Modification of Development Consent

Section 4.55(2) of the *Environmental Planning and Assessment Act 1979*

Applicant Number:	SSD 7348
Applicant:	Goodman Property Services (Aust) Pty Ltd
Consent Authority:	Minister for Planning and Public Spaces
Site	Lot 1 DP 663937, Lot 2 DP 1215268, Lot 6 DP 229784, Lot 2 DP 84578, Lot 3 DP 85393 and Lot 11 DP 1178389 2 Aldington Road, Kemps Creek NSW 2178
For the following:	A Concept Proposal including: <ul style="list-style-type: none">• concept layout of 22 warehouse buildings inclusive of dock offices and ancillary offices providing 476,000 square metres of gross lettable area, built over five development stages;• concept layout of development lots, internal roads, drainage, landscaping, noise walls, basins and biodiversity offsets; and• development controls A Stage 1 Development including: <ul style="list-style-type: none">• bulk earthworks across all five stages including retaining walls and noise walls;• lead in services including but not limited to drainage, power, sewer, water and telecommunications;• service infrastructure to Precinct 1, including drainage, power, sewer, water and telecommunications;• construction and operation of thr

Figure 3: Stage 1 DA Layout

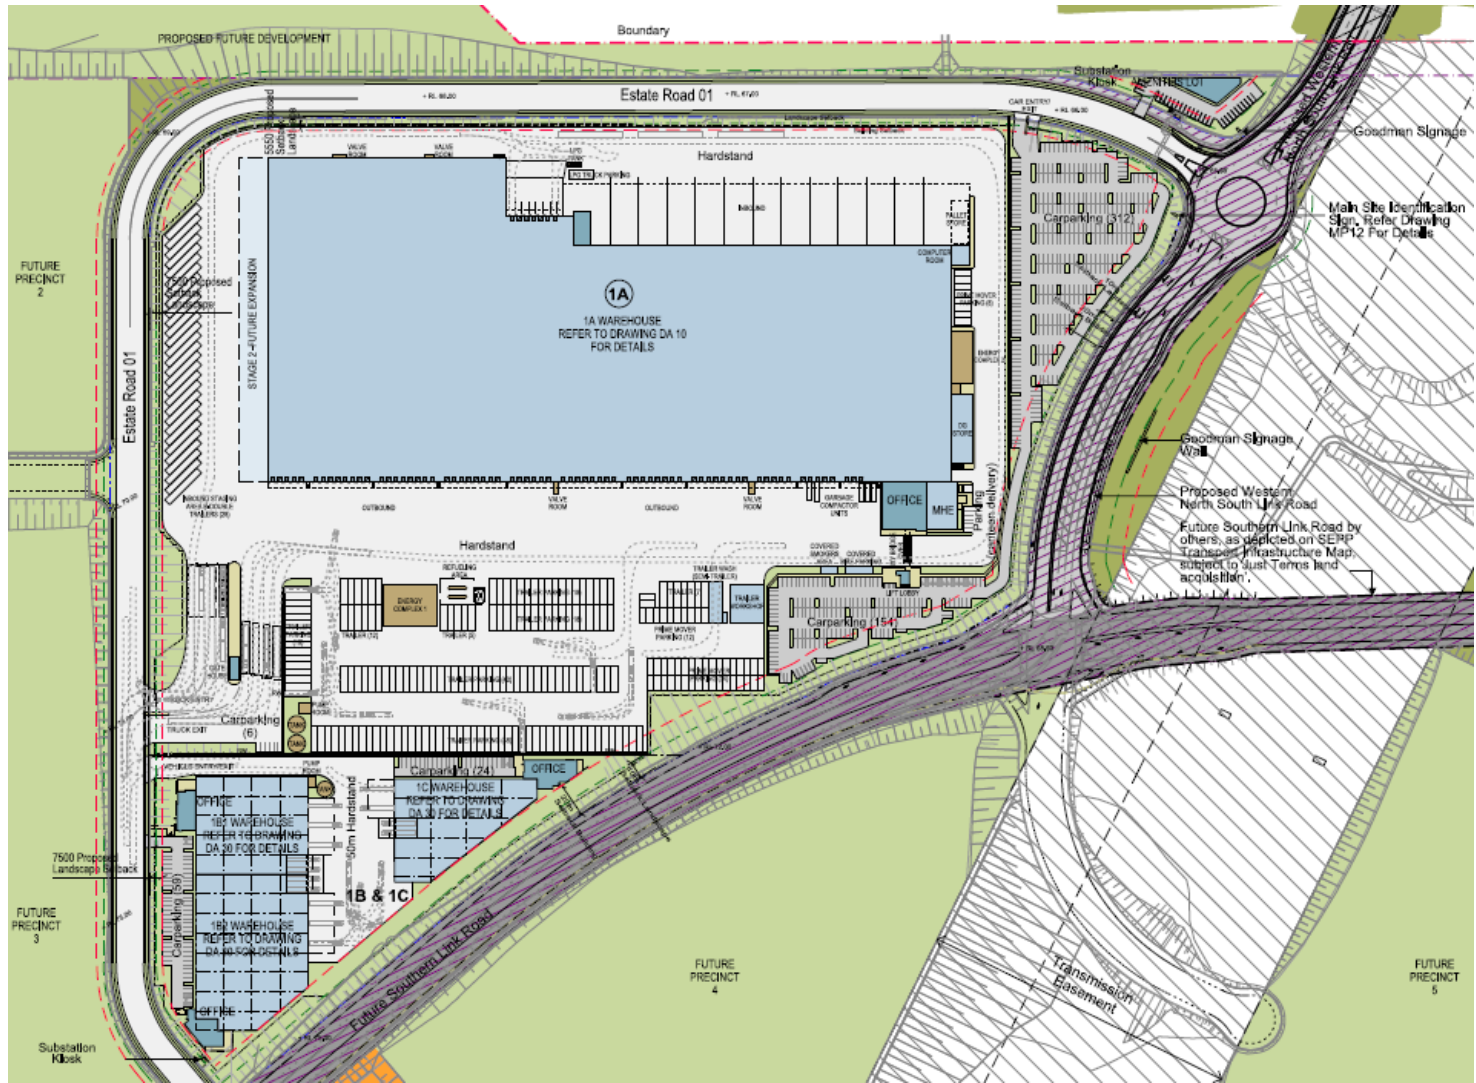
25. Replace Figures 3, 4 and 5 in Appendix 2 with two new figures as follows:

Figure 3: Stage 1 DA Detail

Figure 1B: Noise Receivers and Noise Wall Locations (MOD 2)

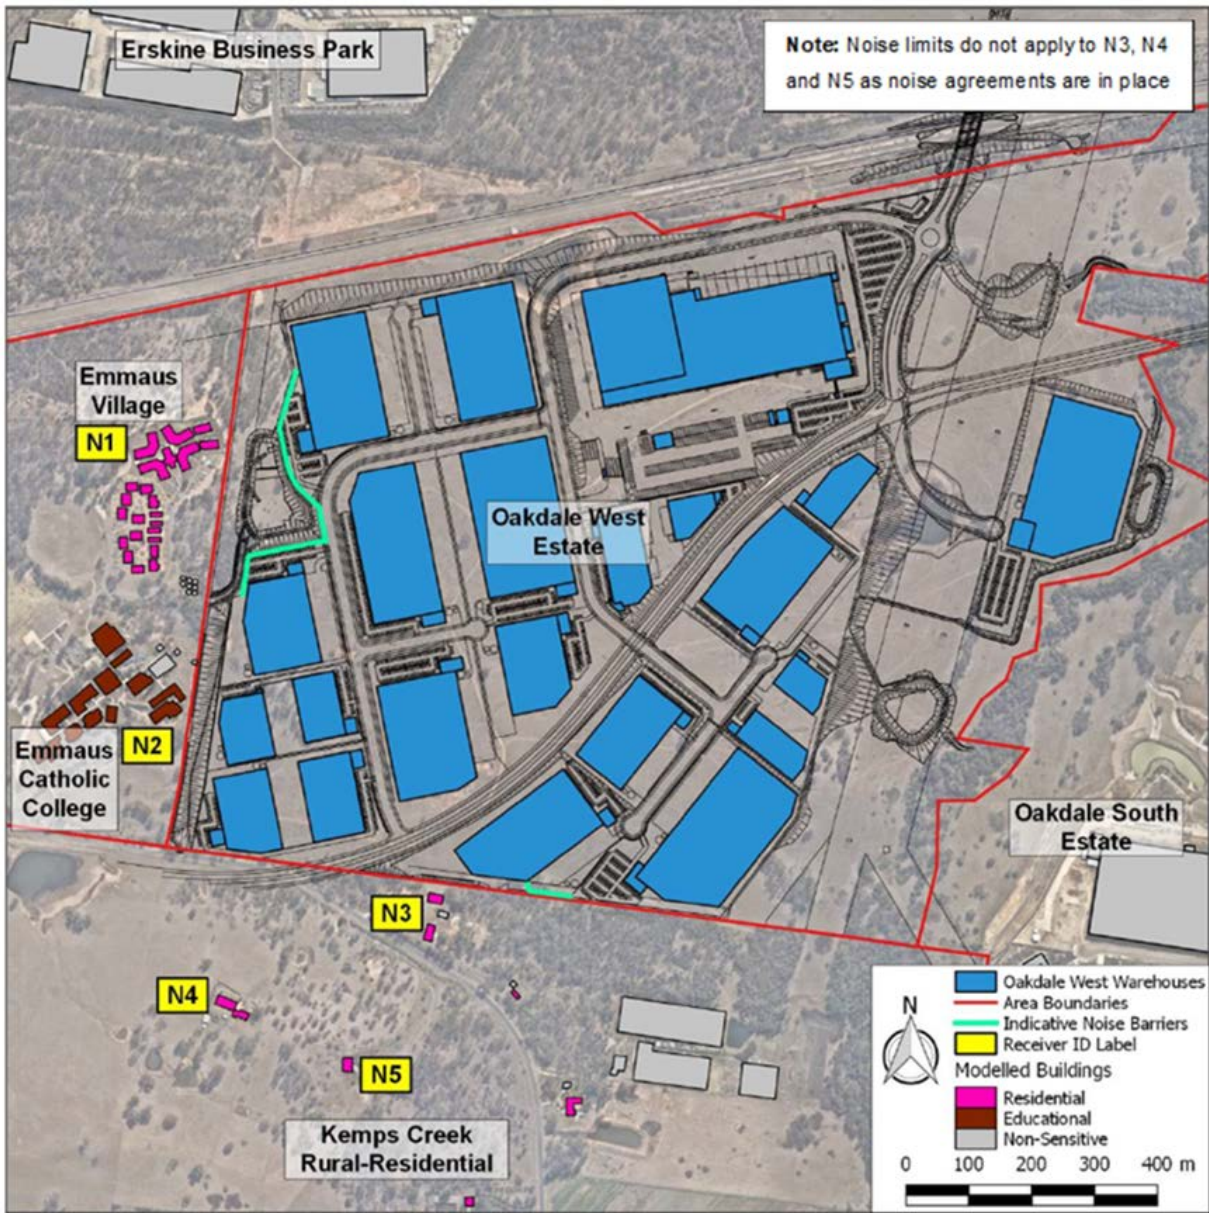
- Noise Barrier**
- D75(c) The Applicant must install the noise barrier as shown on Figure 7B in Appendix 5, no later than 31 October 2020, unless the noise barrier is installed in accordance with Condition D75(a).

26. Insert new Figure 7B in Appendix 5 as follows:

Figure 7B: Noise Receivers and Noise Wall Locations (MOD 2)
